Item Name: Shim

ENGINEERING CHANGE NOTICE NL 04510

DWG NO. 647,4100

DWG TITLE: SHEETMETAL

SHEET 1, ZONE C2 IS:

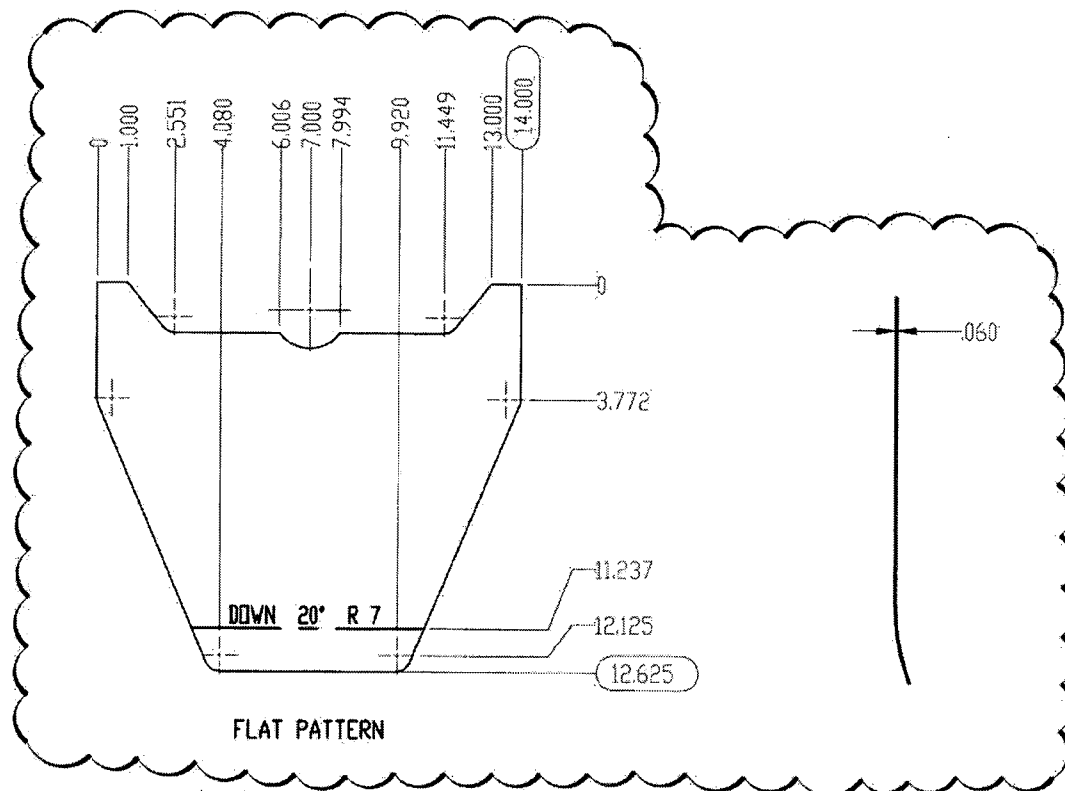
REASON: MODIFIED DOUBLER.

SHEET 1, ZONE A1 IS:

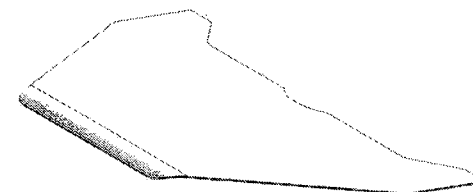
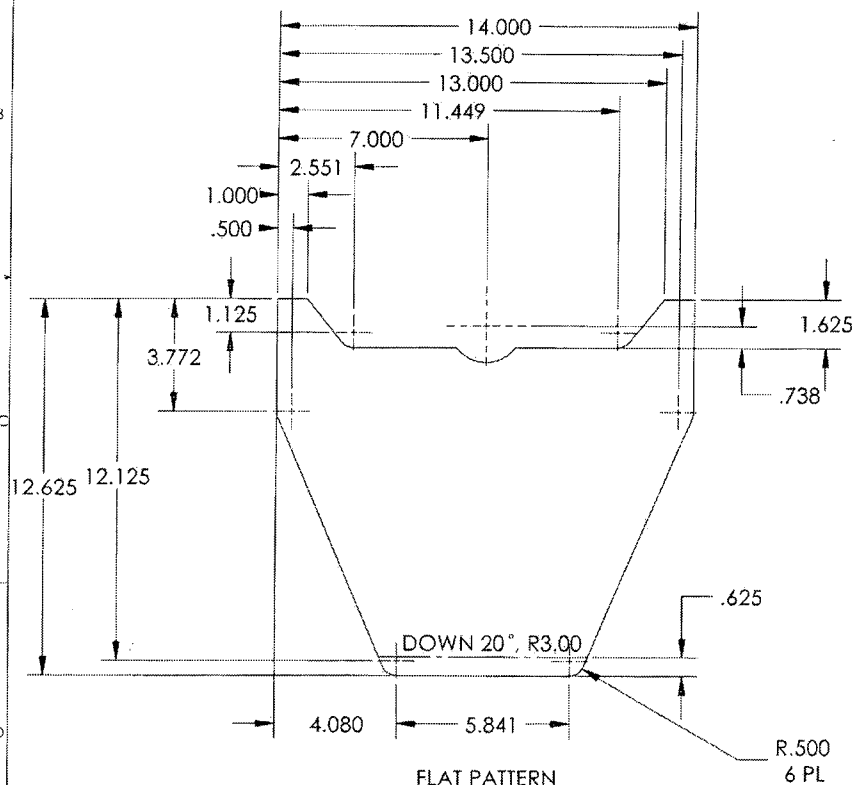
REASON: CHANGED PRETREATMENT CALLOUT

2. FINISH: HARD ANODIZE IAW MIL-A-8625 TYPE II,
CLASS 2, COLOR BLACK;
PRETREAT PR-148 ADHESION PROMOTER
PRIME IAW MIL-P-23377J TYPE I CLASS N

1. MATERIAL: ALUMINUM 2024-T3 PER AMS-QQ-A-250/4
2. FINISH: HARD ANODIZE IAW MIL-A-8625 TYPE II, CLASS 2, COLOR BLACK;
CARDINAL 4860-50 PRETREATMENT PRIMER
PRIME IAW MIL-P-23377J TYPE I CLASS N
3. DEBURR AND BREAK ALL SHARP EDGES
4. IDENTIFY IAW MPP-120
